August 28, 2018
BOARD OF COUNTY COMMISSIONERS
ORANGE COUNTY, FLORIDA
Addendum No. 2, IFB Y18-789-EB
BARBER PARK PLAYGROUND IMPROVEMENTS

BARBER PARK
PLAYGROUND IMPROVEMENTS
3701 GATLIN AVENUE, ORLANDO, FL 32812

GRADING PLAN - PLAYGROUND

SHEET NUMBER
C.5
OF 19 SHEETS

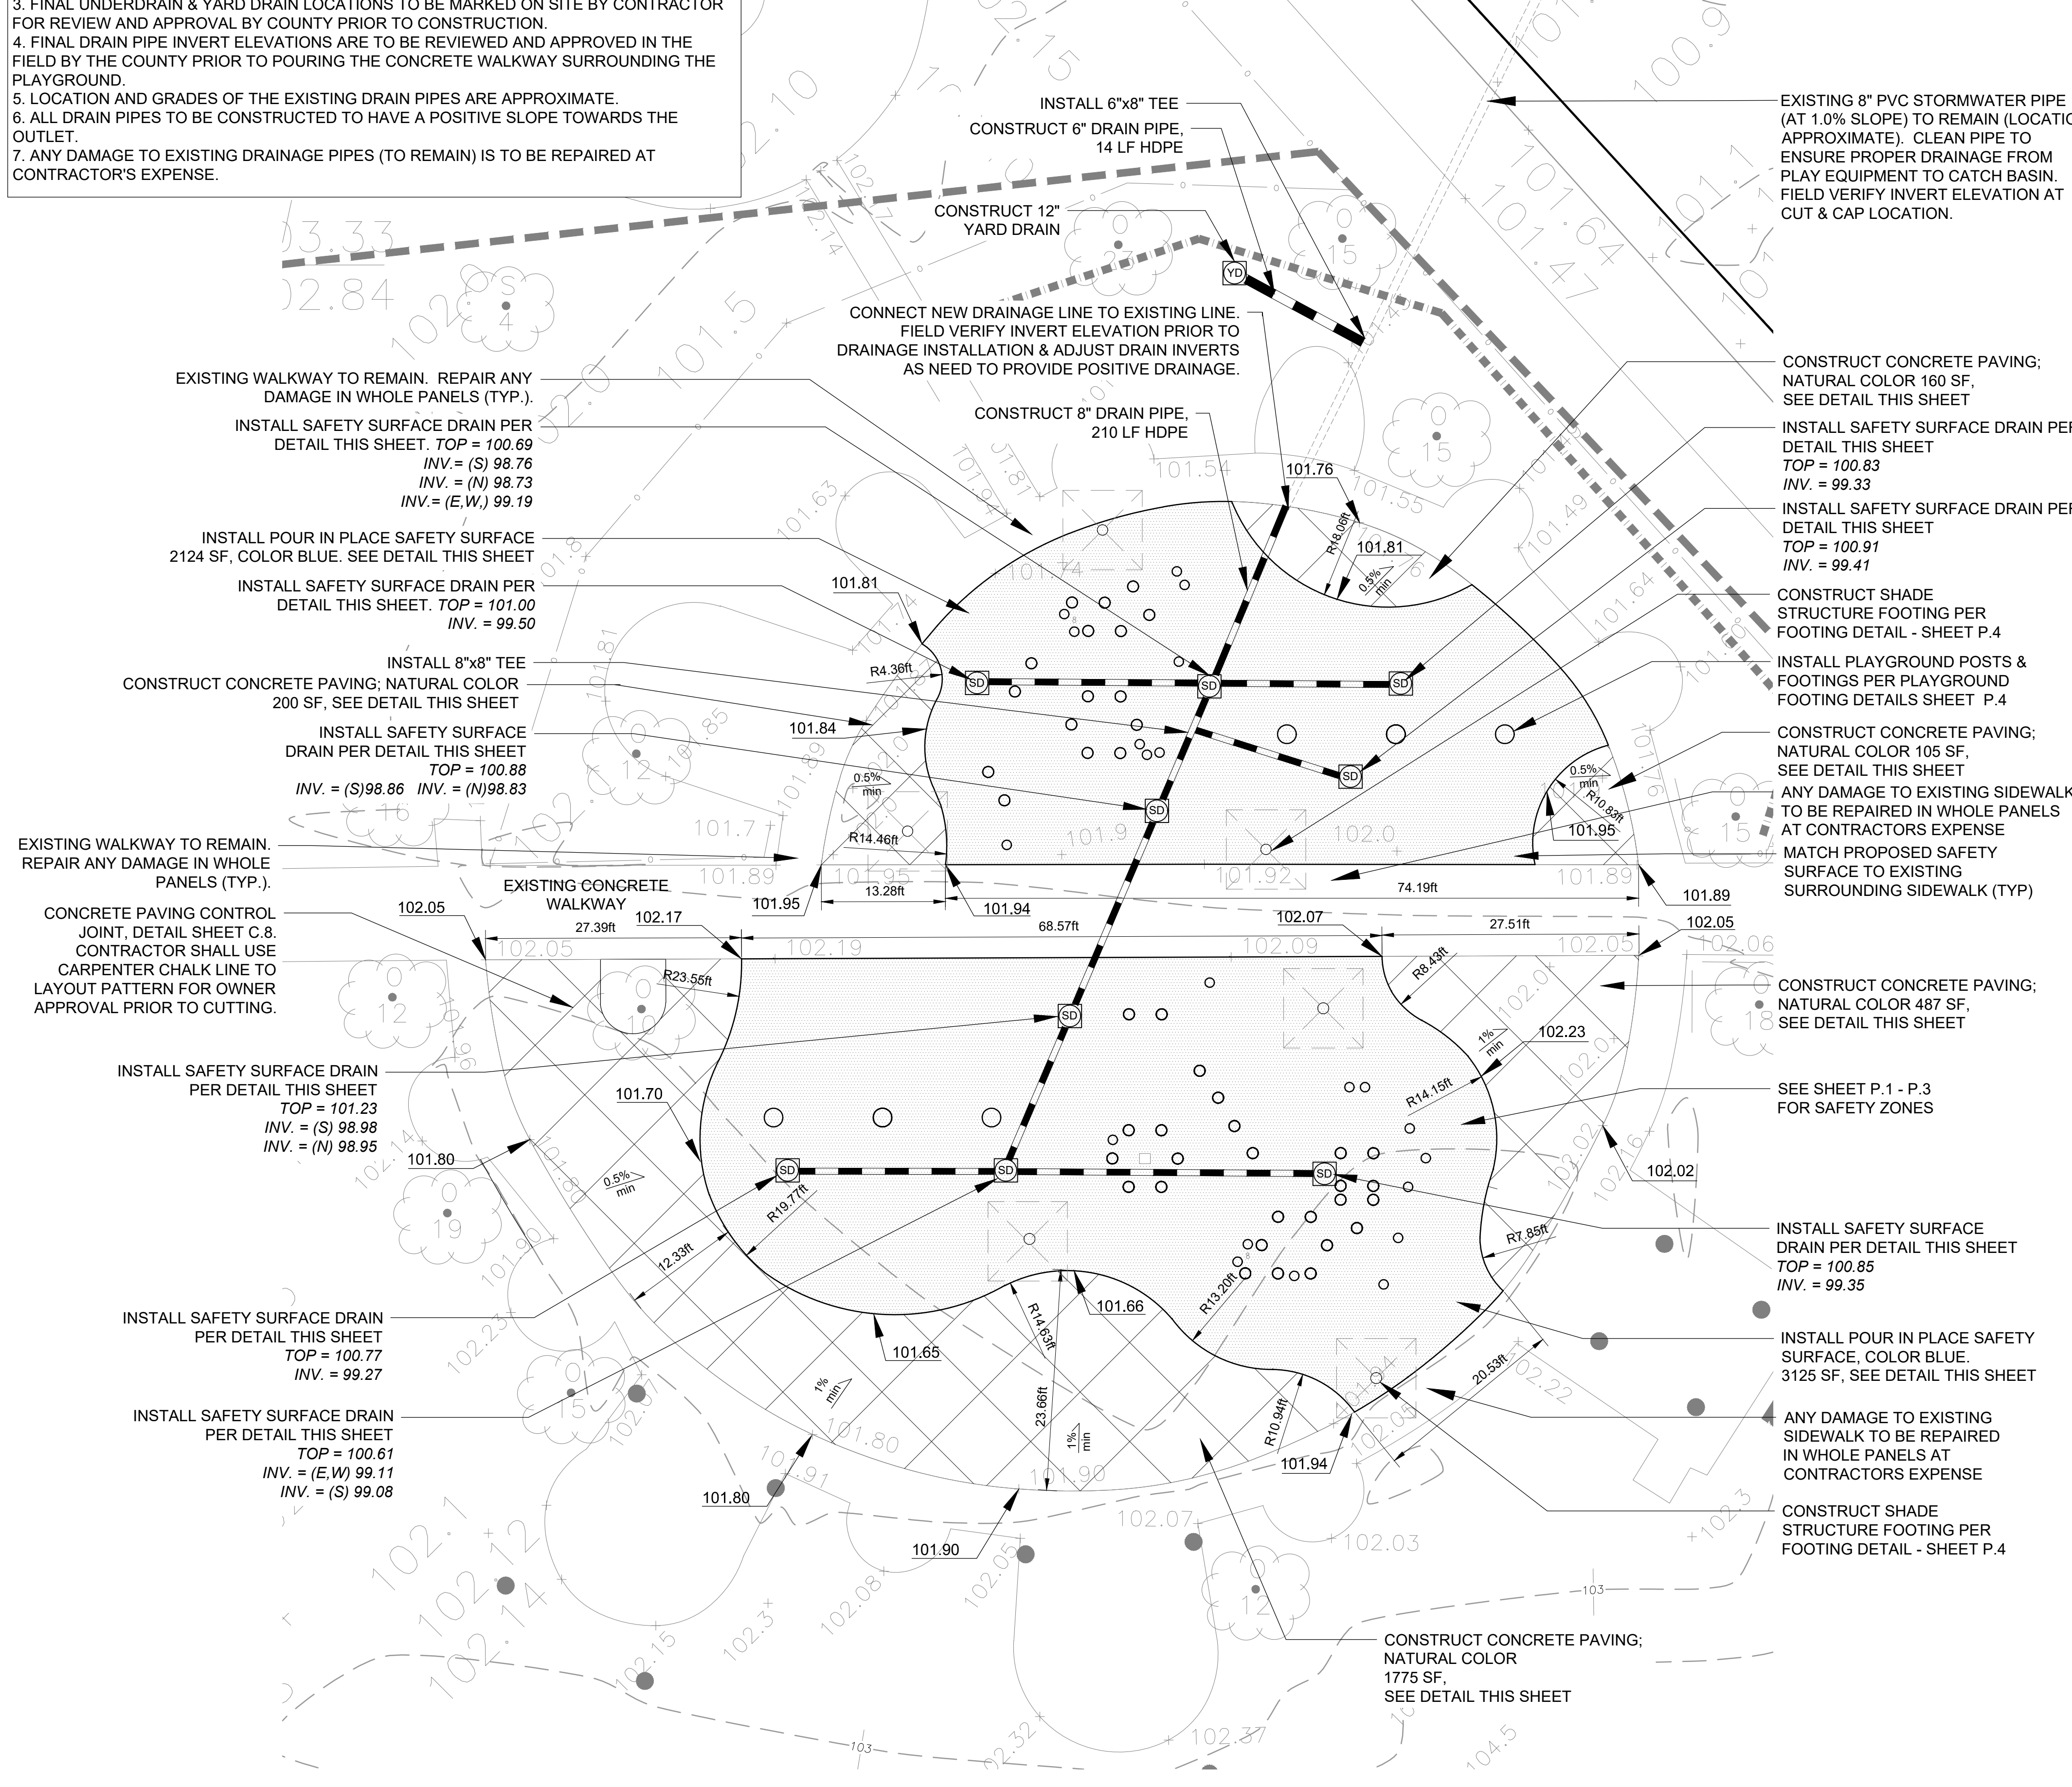
- 5. Question:** On sheet P.2, left hand side under Surfacing it states 2,124 SF of Poured In Place Rubber. That is in conflict with the Note on Sheet C.5 that states that area is 3,125 SF of Poured in Place. 1,000 SF difference could have a large impact on the project and quotes. Will you please help clarify which is correct for construction 2,124,SF or 3,125,SF ? **Answer:** For clarification the approximate quantity is 3,125 square feet. However as this is a lump sum project, square footage shall not be dictated by a note on the documents.

SAFETY SURFACE/FOOTING FILL DETAIL NTS

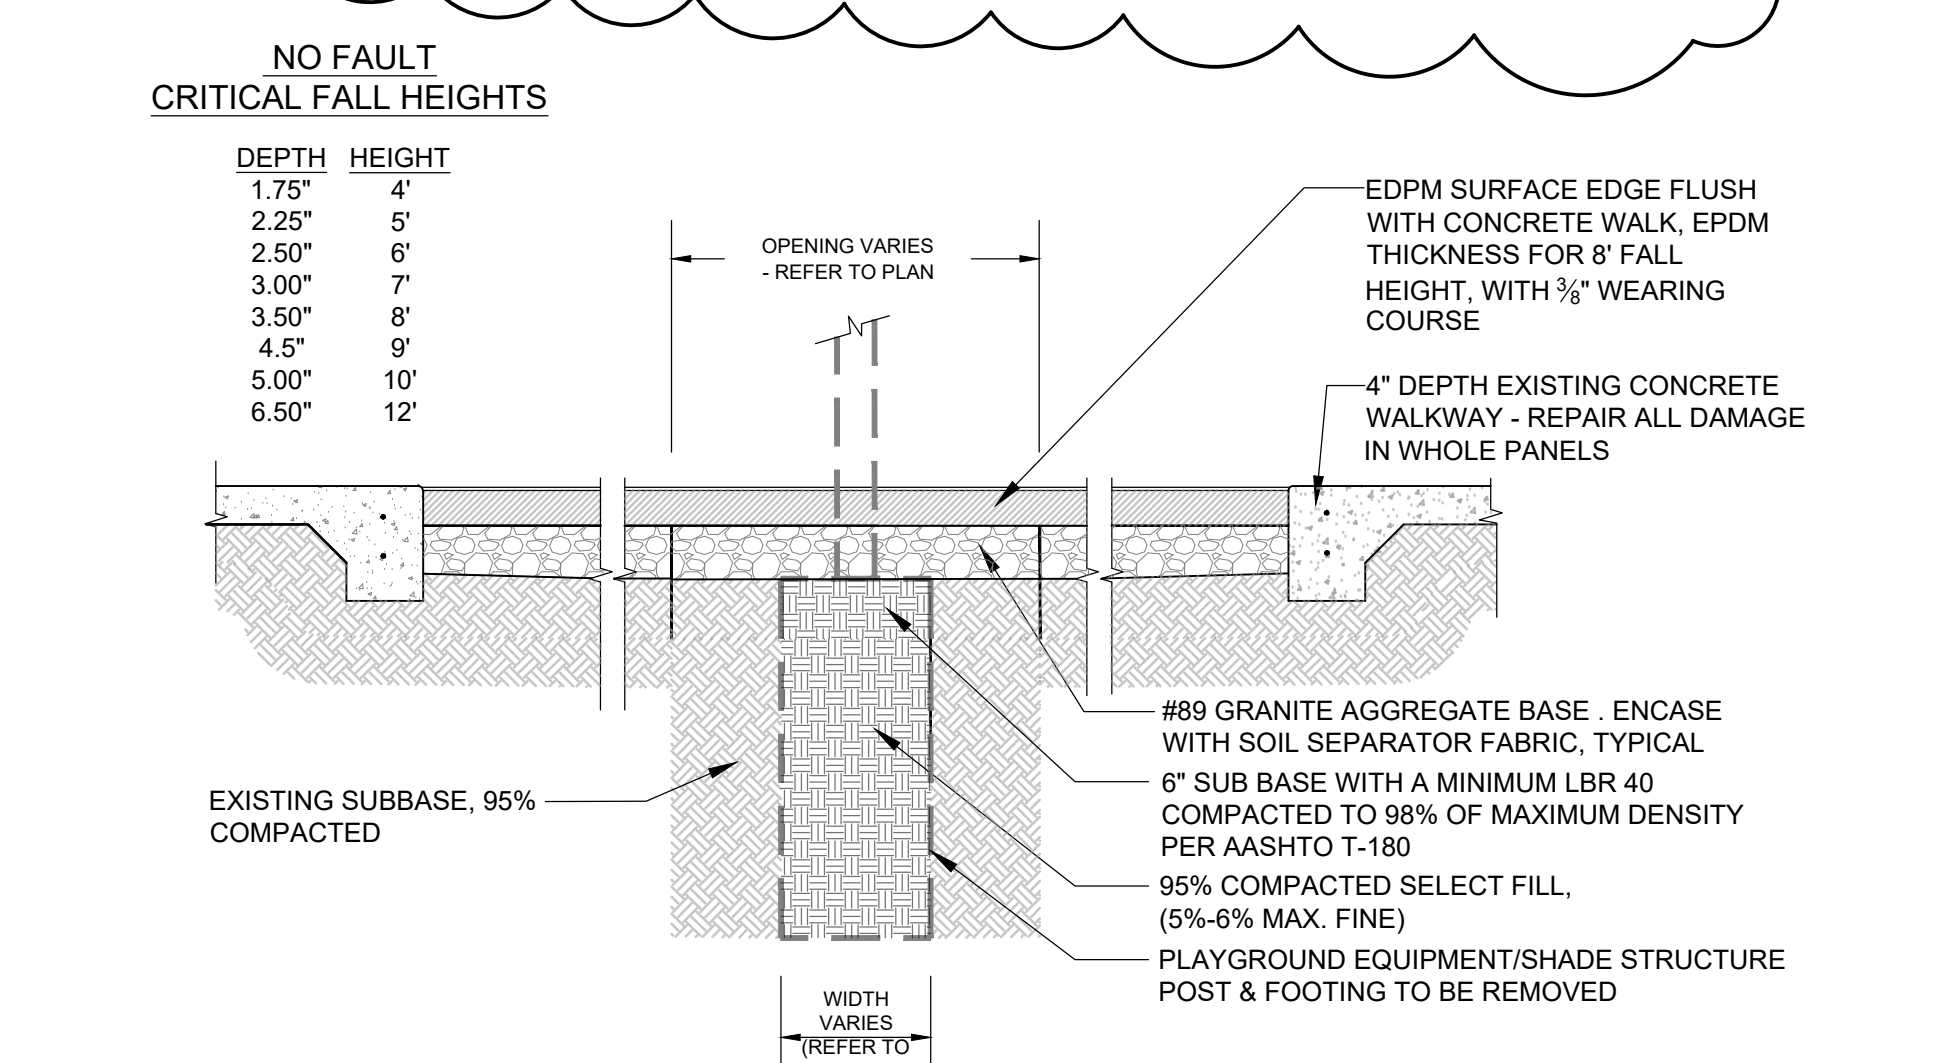
- 1. Question:** On sheet C.5 of the revised drawings, there is a detail in the top right corner that seems to be missing a layer. Please provide the full detail for bidding purposes. **Answer:** The detail has been amended and revised sheet C.5 is included with this Addendum.

- 2. Question** There is no detail concerning the edge of new concrete surfaces where it will meet the new pour-in-place surfacing. Will new concrete have turn-down edges where it meets new pour-in-place surfacing? **Answer:**The detail on the revised sheet C.5 shows and calls out the turned down edge.

- 3. Question:** On sheet C.5 of the revised drawings, the Safety Surface/Footing Fill Detail calls for #89 granite stone as a sub-base for the new pour-in-place surfacing. This type of granite stone is typically difficult to find in Florida. Will any alternate sub-base material be acceptable for the project? **Answer:** No substitutions will be allowed. #89 Granite shall be utilized as the aggregate base as shown on the plans and specifications.
